REMARKS

A MAGNETO-RESISTIVE...
Serial No. 09/400,110
Greer, Bullock, Herbold Ltd.
Our Ref. No. 0940011074
Annotated marked-up drawing of Figure 3E

FIG. 3E

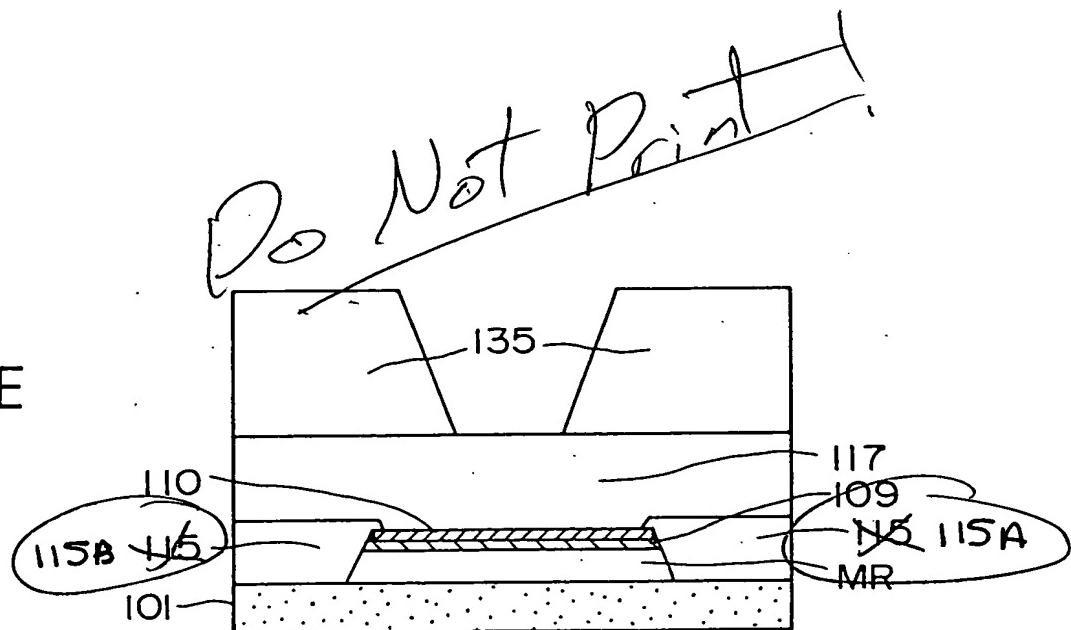
As a preliminary matter, with regard to the drawings, Applicants have included herewith a marked-up copy of Figure 3E, with the proposed changes in red. The dual inclusion of reference number 115 has been corrected by changing it to reference numbers 115A and 115B, which is consistent with Figures 3C, 3D, 3F and 3G. Approval of the proposed drawing changes is respectfully requested. With regard to the objection to Figure 3G, which was objected to because reference number 144 was not mentioned in the specification, the specification has been amended to include mention of this reference number. More specifically, line 8 of page 12 has been amended to refer to "Ar ions 144." Accordingly, in light of the corrections mentioned above, withdrawal of the Examiner's objections to the drawings is respectfully requested.
